**Duke Power**

Subject: Duke Energy Corporation  
Oconee Nuclear Station, Units 1, 2 and 3  
Docket Numbers 50-269, 50-270 and 50-287  
Request for Exemption to 10CFR50.44, 10CFR50, Appendix A, General  
Design Criterion 41, and 10CFR50, Appendix E, Section VI.  
Proposed Technical Specification Change Concerning  
Hydrogen Control System (TSCR 2000-05)

This is a request to revise Oconee Nuclear Station, Units 1, 2, and 3 Technical Specification (TS) 3.3.8, "Post Accident Monitoring (PAM) Instrumentation," and the associated TS Bases. Additionally, Selected Licensee Commitment (SLC), 16.6.10, "Containment Hydrogen Recombiner System," would be deleted on approval of this application. Other changes described in this enclosure would be implemented on approval of the exemption requested provided in Enclosure 1 and this license amendment application.

Condition C is modified by a Note indicating this Condition is not applicable to PAM Functions ~~10, 14, 18, 19, 20, and 22.~~

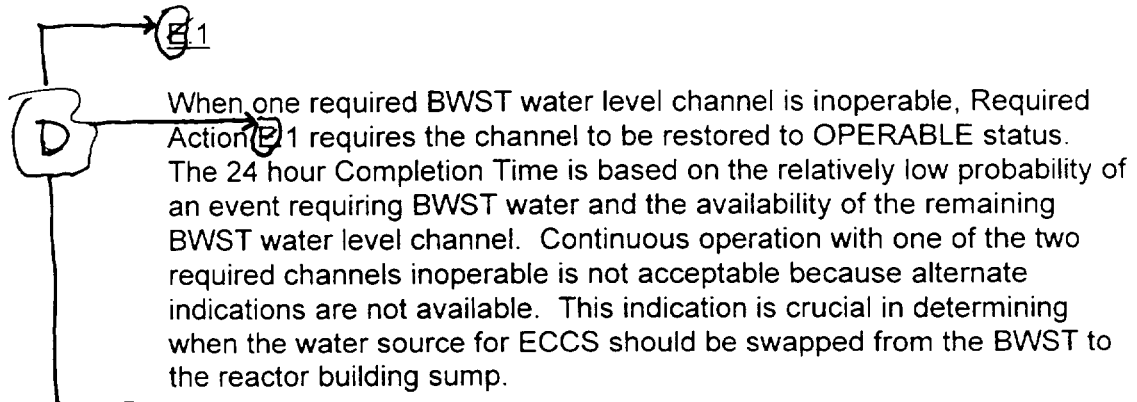
13, 17, 18, 19, AND 21.

Condition E is modified by a Note indicating this Condition is only applicable to PAM Function ~~14.~~

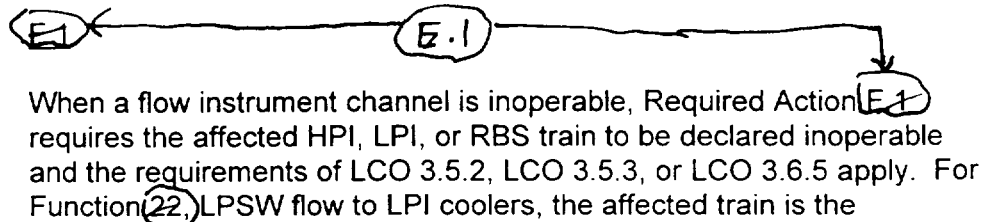
13.

21,

G.1 and H.2 → G → F

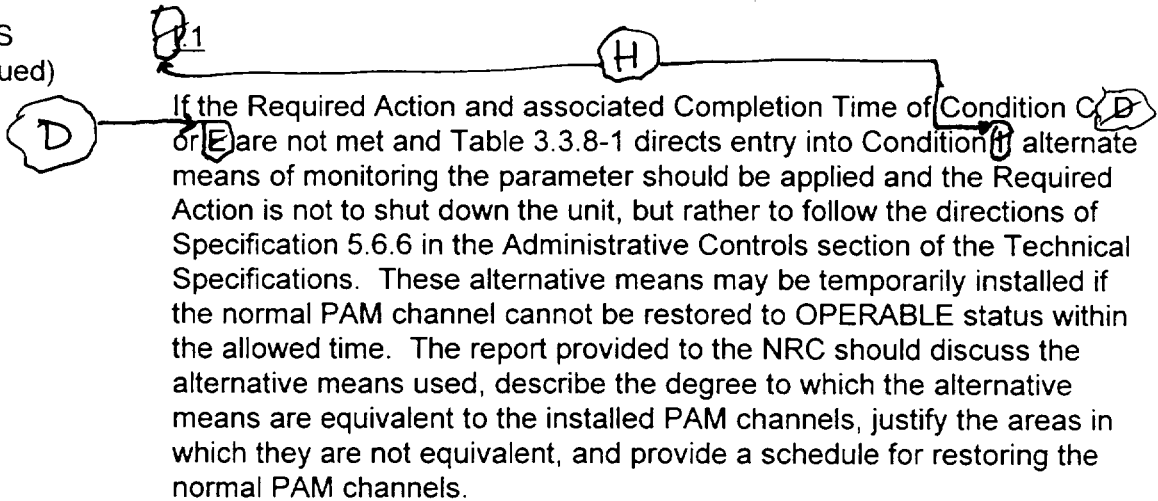
If the Required Action and associated Completion Time of Conditions C, D or E are not met and Table 3.3.8-1 directs entry into Condition H, the unit must be brought to a MODE in which the requirements of this LCO do not apply. To achieve this status, the unit must be brought to at least MODE 3 within 12 hours and MODE 4 within 18 hours. The allowed Completion Times are reasonable, based on operating experience, to reach the required unit conditions from full power conditions in an orderly manner and without challenging unit systems.

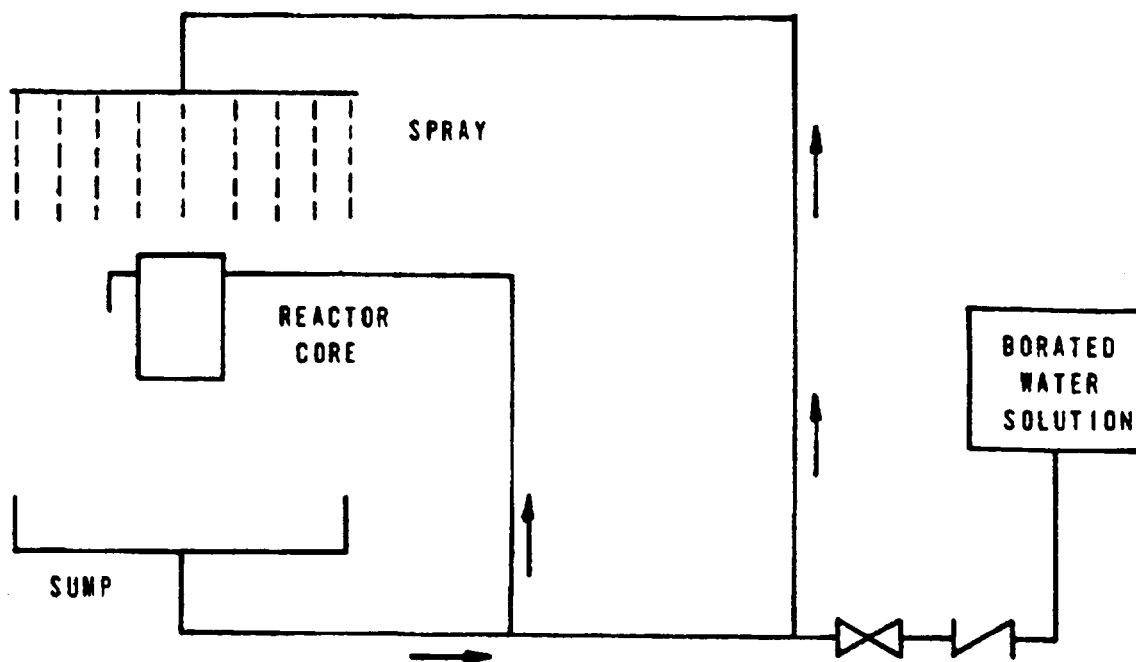
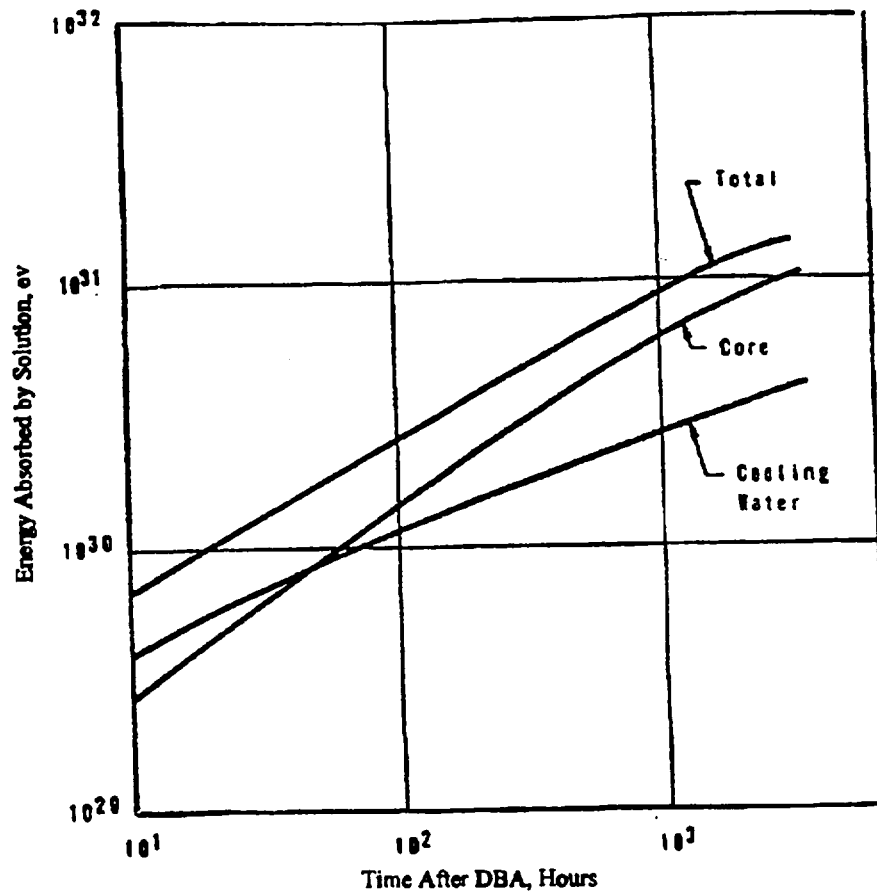
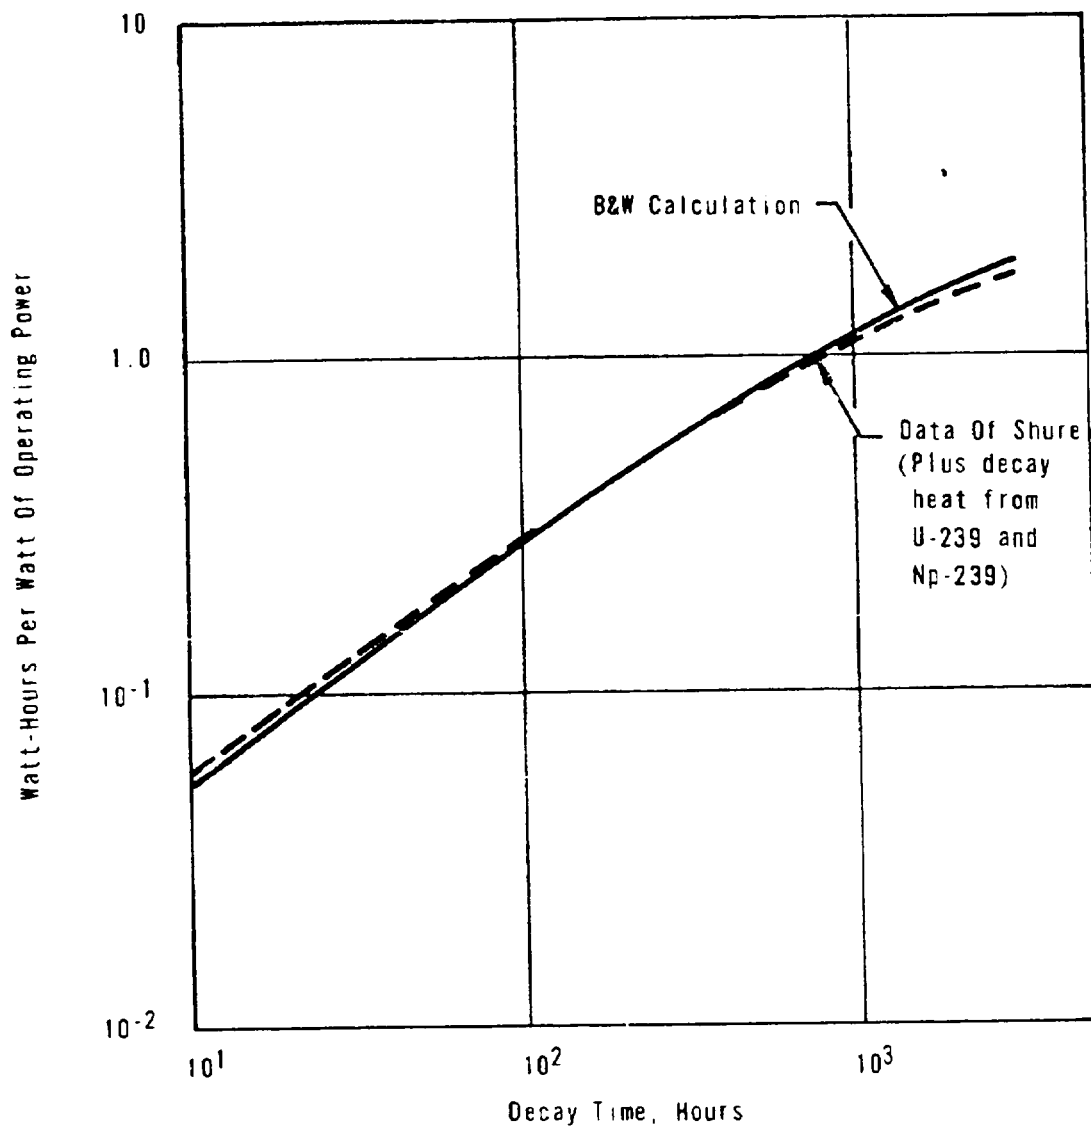
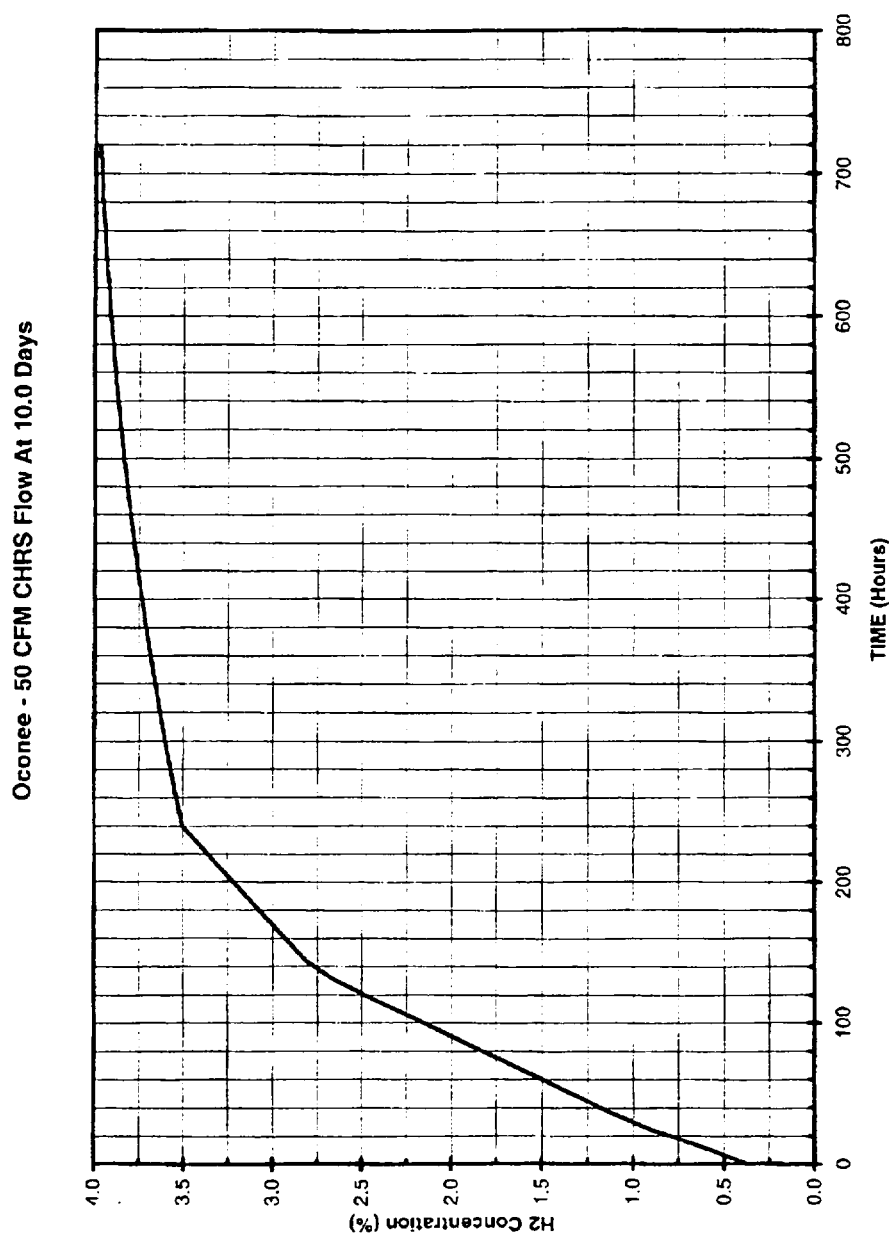
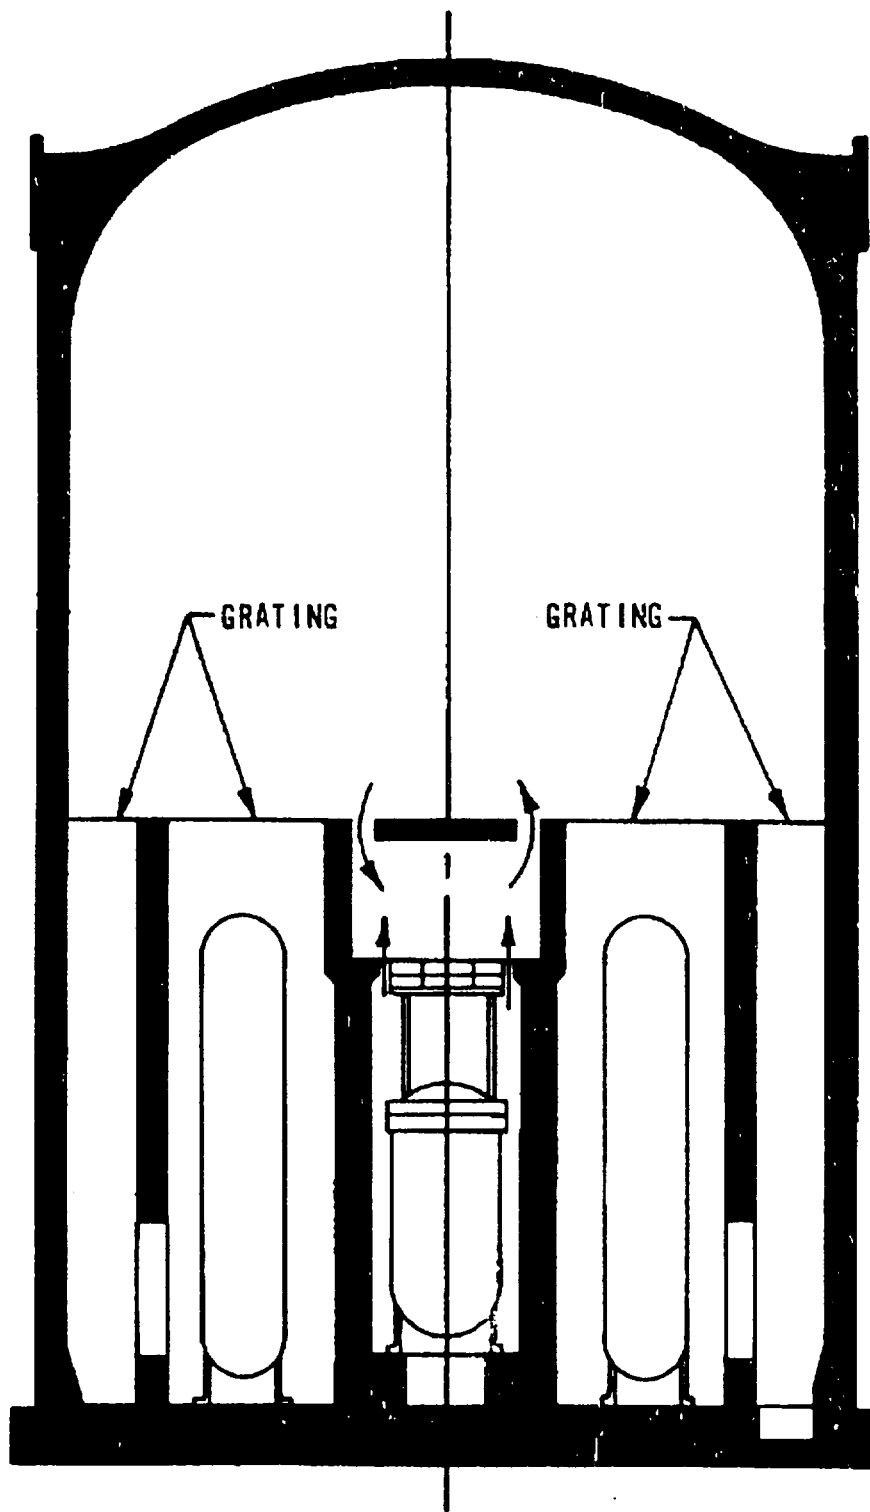
- UFSAR § 15.16, "Post-accident Hydrogen Control" (Attachment C-4) will be revised to remove all references to hydrogen monitoring and recombination, and the potential effects of hydrogen combustion on the Reactor Building (containment). This revision would also include removal of the related tables and figures from UFSAR § 15.16.
